MEDICAL OFFICE BUILDING
Texas

TEXAS ACCESSIBILITY STANDARDS PLAN REVIEW

TEXAS ACCESSIBILITY STANDARDS INSPECTION

Fig. 25 b

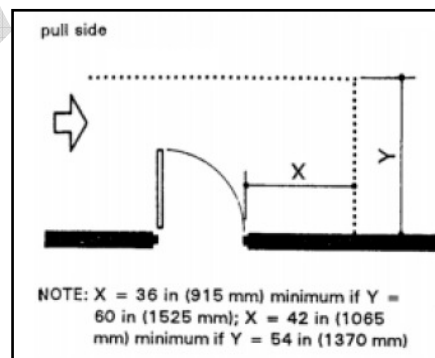
Does Not Comply, Door D48 does not have the minimum maneuvering clearance at the sidewalk (See Fig 25b).

Does Not Comply, Door D02 and D03 do not have the minimum maneuvering clearance (See Fig 25b).

Ramp to public sidewalk
Paint is faded and peeling

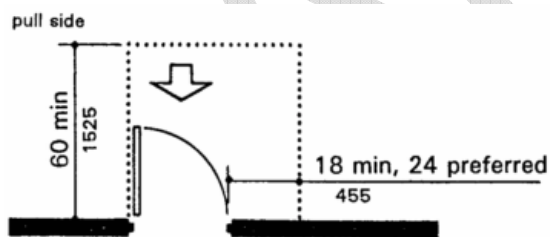
Surface color and contrast is failing at the curb ramps:

Paint on ramps is chipped and all ramps, with chipped paint, should be repainted.
